# Access Compliance Report

## Public Rights-of-Way

Intersection ID: 7270	Main Street: CANTERWOOD_DR	Cross Street: TOM_HUNTER_RD	Location: SW
ADA ID: 2B4FE261ECAD	Ramp Type: PerpDiag	Initial Pass/Fail: Fail	Overall Compliance: No
Severity Score: 10			
Codes/Mitigation Info/Possible Solution		Field Measurements/Component Compliance

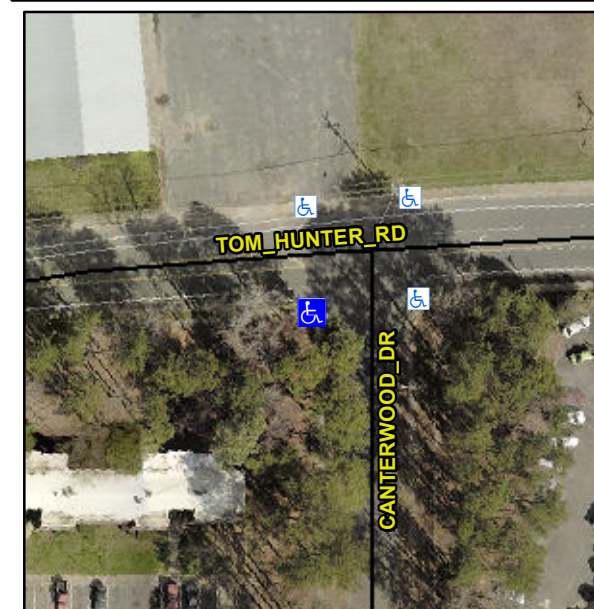
**Not Found, R304.5.1, R304.5.3**

Compliance	Description	Data	Compliance	Description	Data
N/A	Ramp Length (in)	48.0	Yes	Ramp Slope (%)	8.3
No	Ramp Width (in)	44.0	No	Ramp XSlope (%)	2.2
N/A	Flare Type LT	N/A	N/A	Flare Type RT	N/A
N/A	Flare Slope LT (%)	N/A	N/A	Flare Slope RT (%)	N/A
N/A	Flare Traversable LT?	N/A	N/A	Flare Traversable RT?	N/A
N/A	Landing Length (in)	N/A	N/A	DWS Provided?	N/A
N/A	Landing Width (in)	N/A	N/A	DWS Contrast?	N/A
N/A	Landing Slope (%)	N/A	N/A	DWS Length (in)	N/A
N/A	Landing X Slope (%)	N/A	N/A	DWS Full Width?	N/A
N/A	Landing Curb? (Y/N)	N/A	N/A	DWS Offset (in)	N/A
N/A	Shared Landing?	N/A			
N/A	Gutter Ponding?	N/A	N/A	Gutter Slope (%)	N/A
N/A	Gutter Lip Ht (in)	N/A	N/A	Gutter X Slope (%)	N/A
N/A	Painted X Walk1?	No	N/A	Painted X Walk2?	No
	X Walk 1 Direction	To E		X Walk 2 Direction	To N
N/A	X Walk 1 Width (in)	N/A	N/A	X Walk 2 Width (in)	N/A
	X Walk 1 Slope (%)	2.9		X Walk 2 Slope (%)	3.8
	X Walk 1 X Slope (%)	1.1		X Walk 2 X Slope (%)	1.3

**Remove & Replace Curb Ramp With Two New Directional Ramps or Equivalent.**
